ACCESS REPORT

NSW Land and Housing Corporation

**HOUSING FOR SENIORS & PEOPLE WHO LIVE WITH
DISABILITY**

98-102 Albert Street, REVESBY NSW

Access to Public Transport

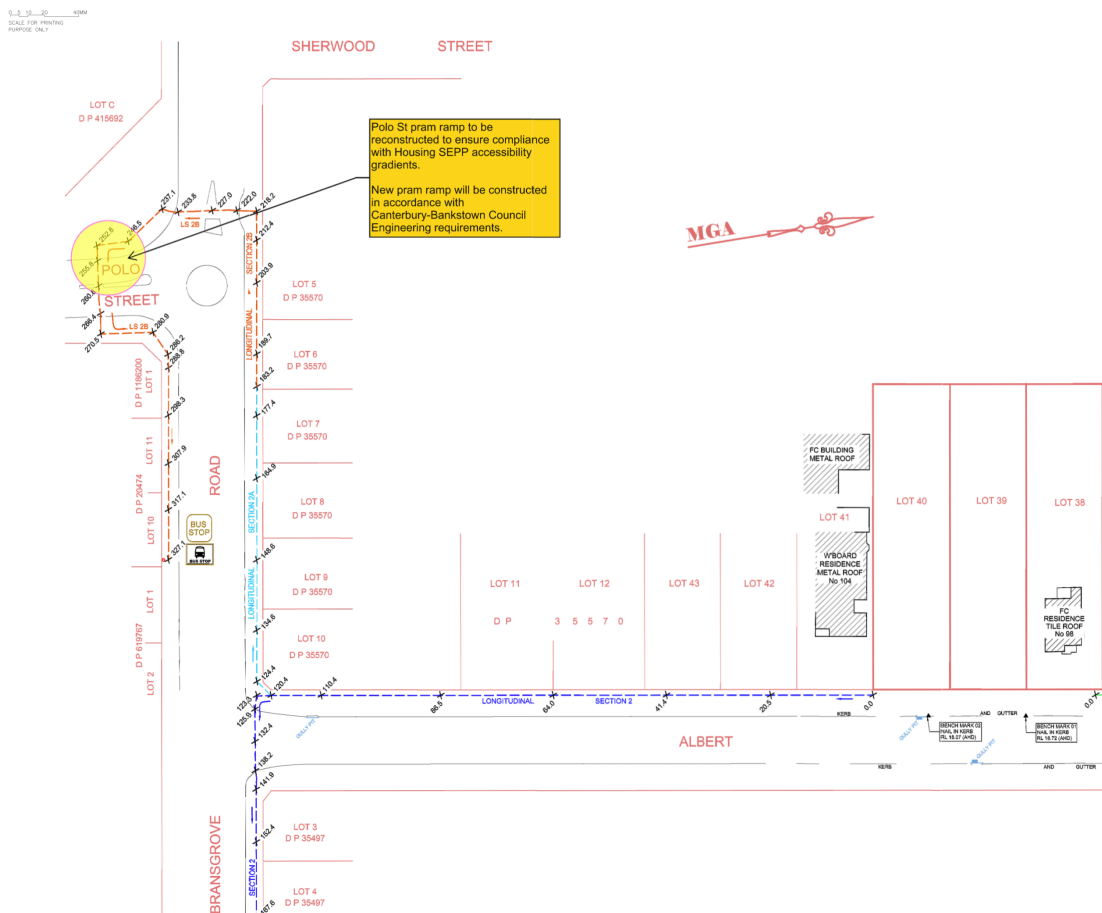
There is an accessible sealed footpath the length of Albert Street and along Bransgrove Road. The nearest bus stop (pictured) requires residents to cross Bransgrove Road at the intersection of Albert St and Bransgrove Road.

There is an existing diagonal direction kerb ramp at the intersection of Albert Street & Bransgrove Road which does not meet requirements for safe alignment of AS1428.1 Clause 10.7.1 & Figs 23, 24

There are four compliant options to access public transport, within 400m of the property boundary, as per SEPP Housing 2021 Part 5. The preferred route is indicated on the plan above.

We strongly recommend the installation of a compliant kerb ramps, at Polo St, as indicated above. The existing sanctuary traffic island at the roundabout intersection of Polo Street and Bransgrove Road provides for safe crossing, then proceed to the next bus stop.
